## TOWN OF YORKTOWN PLANNING BOARD

### PUBLIC MEETING AGENDA YORKTOWN TOWN HALL BOARD ROOM 363 Underhill Avenue, Yorktown Heights, NY 10598

December 20, 2021

6. **Foothill Street Solar**

**Figure 1:**  
**A-Weighted Sound Level Contours**  
 due to the Yorktown A Solar Farm

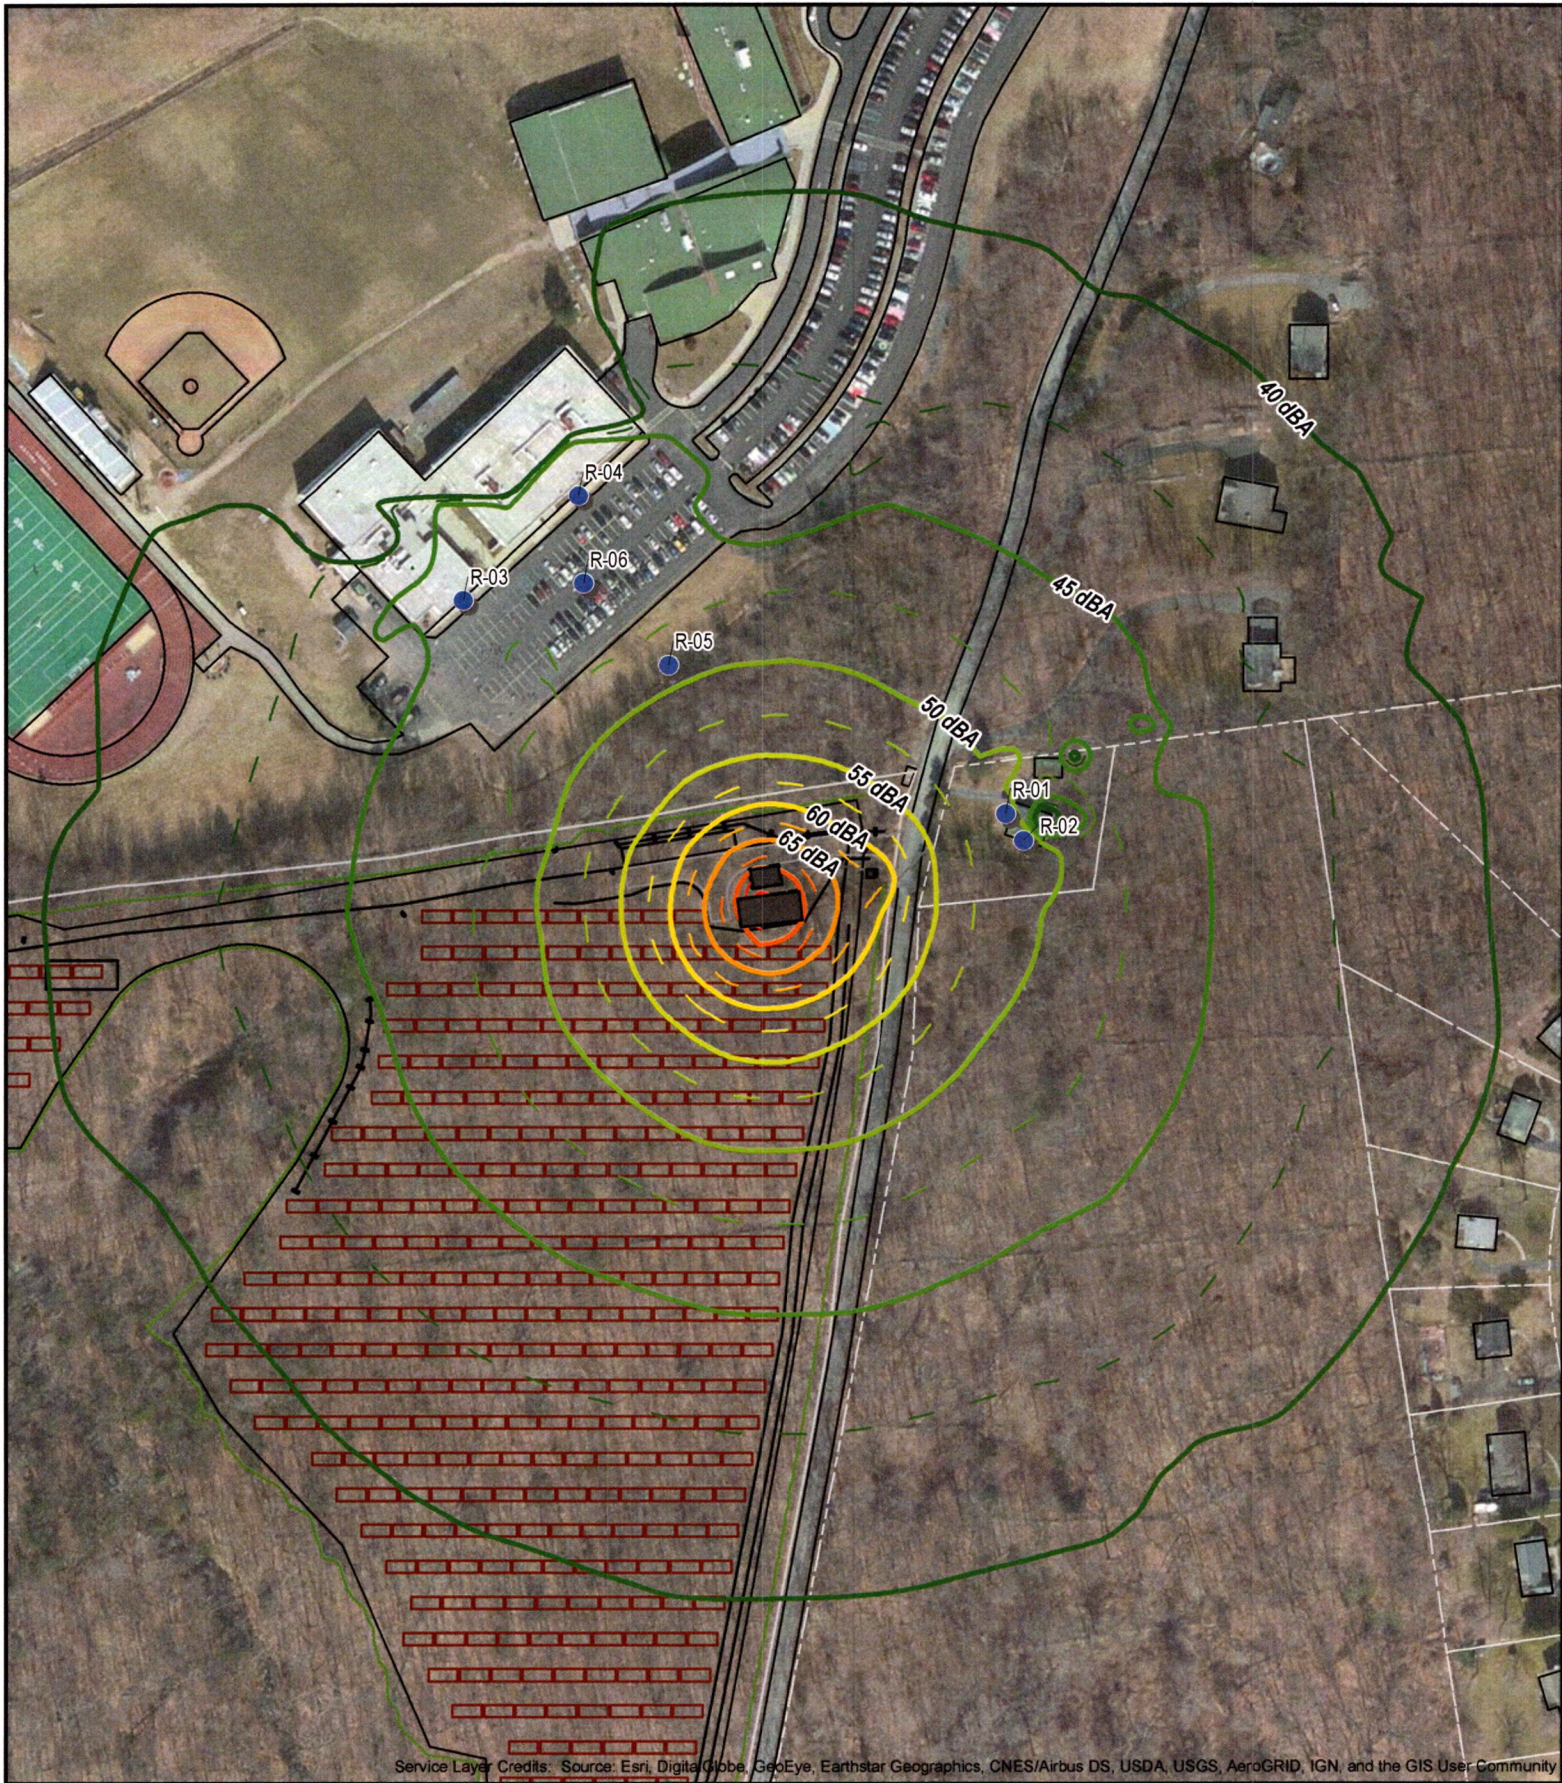
1. Please show the actual locations of all inverters and recalculate the decibels in relation to said locations. All inverters would not be placed where shown in Figure 1.
2. Please depict the Wellness Trail on the noise analysis and ensure that the proposed development will not affect the Wellness Trail.

1. Please show the actual locations of all the invertors and recalculate the decibels in relations to said locations. All invertors would not be placed where shown Figure 1.
2. Please depict the Wellness Trail on the noise analysis and ensure that the proposed development will not affect the Wellness Trail.
